Docket No. 50-244
LS05-81-

By letter dated March 26, 1981, we issued Amendment No. 38 to Provisional Operating License No. DPR-18 for the R. E. Ginna Nuclear Power Plant. Amendment No. 38 approved technical specifications related to degraded grid voltage protection for the Class IE power system.

UNITED STATES NUCLEAR REGULATORY COMMISSIONDOCKET NO. 50-244ROCHESTER GAS AND ELECTRIC CORPORATIONREVISED NOTICE OF ISSUANCE OF AMENDMENT TO
PROVISIONAL OPERATING LICENSE

FIG. 2.3-1

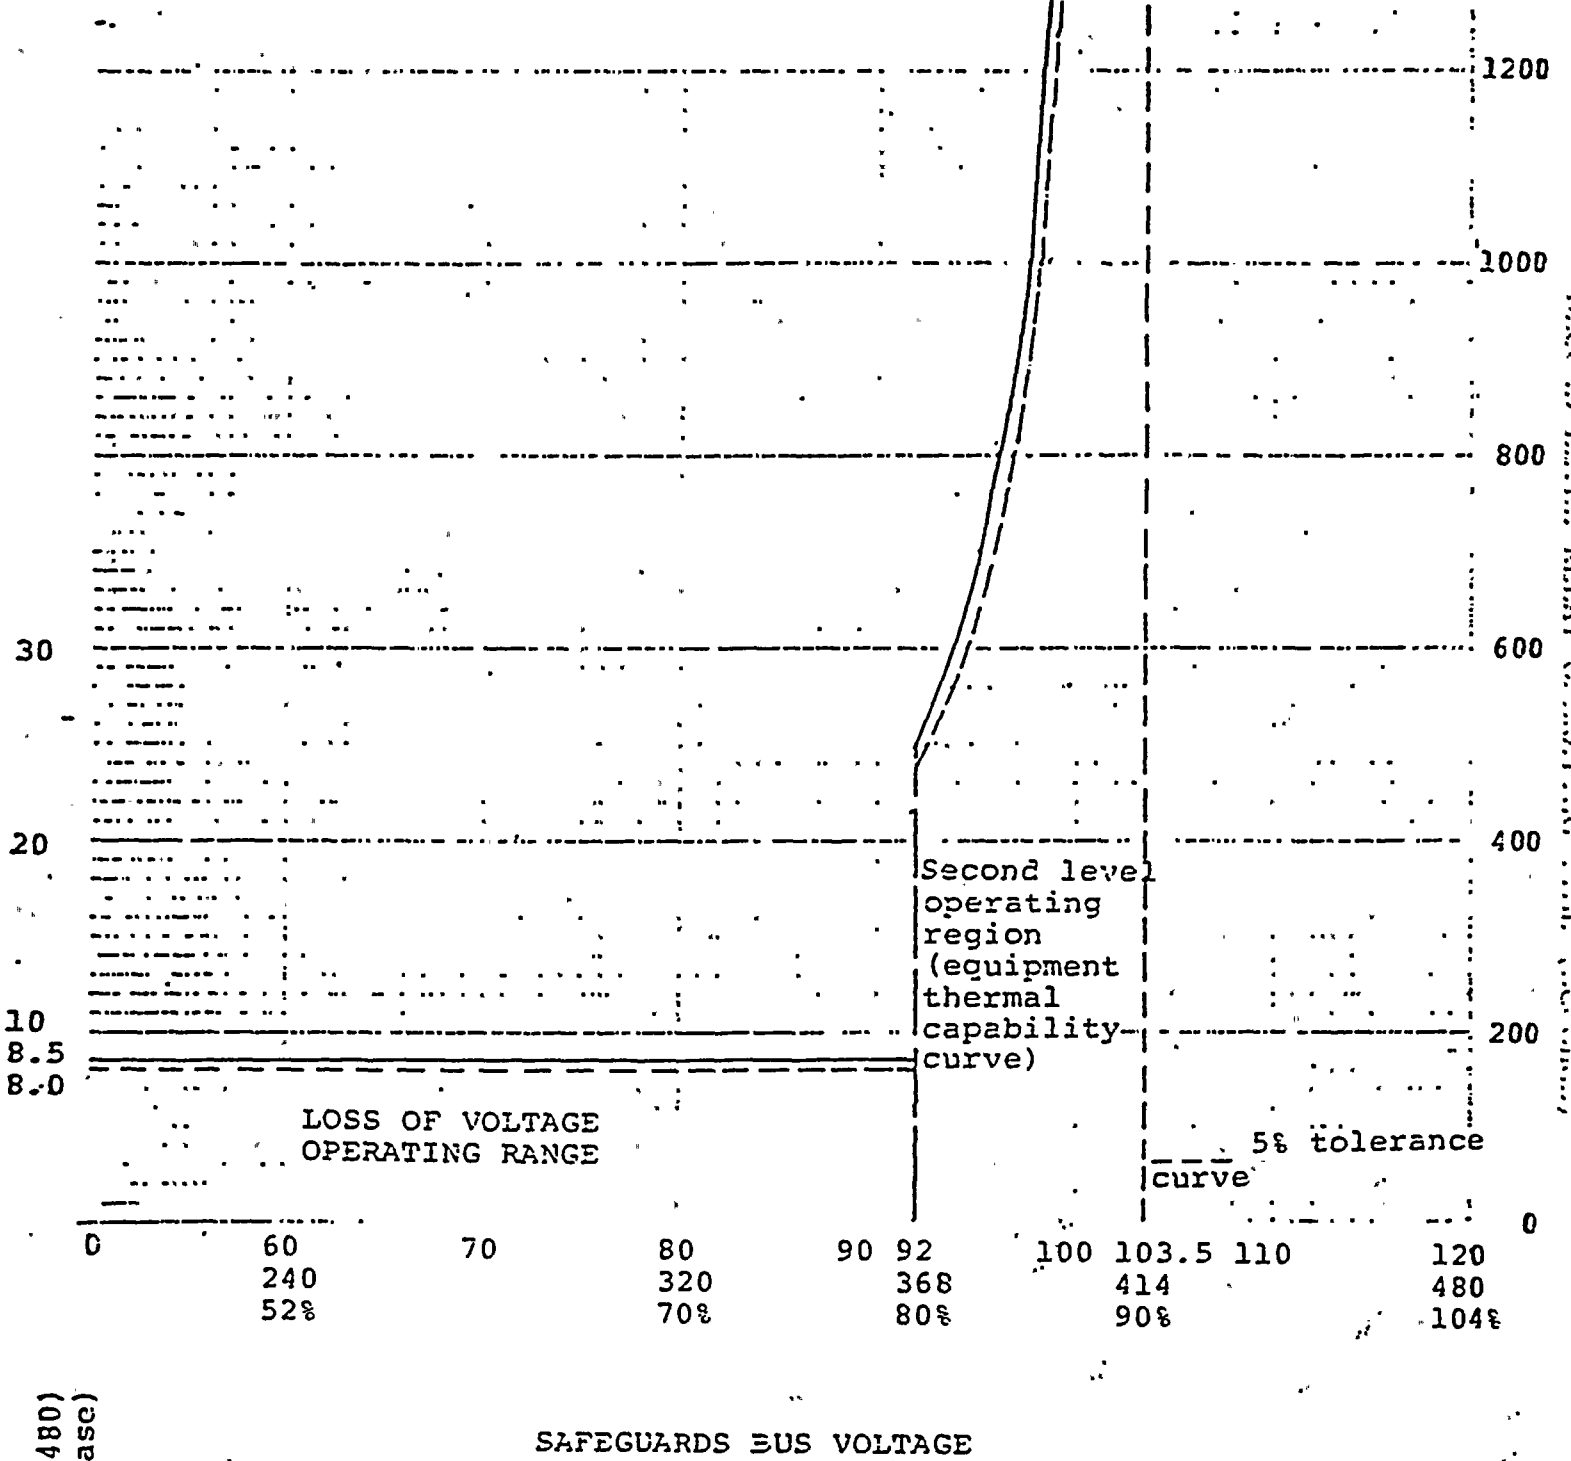
2.3.3.2* Acceptable degraded voltage relay operating times and setpoints, for 480 volt safeguards bus voltages \leq 414 volts and $>$ 368 volts are defined by the safeguard equipment thermal capability curve shown in Figure 2.3-1. Measured values shall fall at least 5% below the theoretical limit. This 5% margin is shown as the 5% tolerance curve in Figure 2.3-1.

The 5% tolerance curve in Figure 2.3-1 and the requirements of specifications 2.3.3.1 and 2.3.3.2 include 5% allowance for measurement error. Thus, providing the measurement error is less than 5%, measured values may be directly compared to the curve. If measurement error exceeds 5%, appropriate allowance shall be made.

*Effective 30 days after completion of necessary modifications and no later than completion of the Spring 1982 refueling outage
 2.3-10
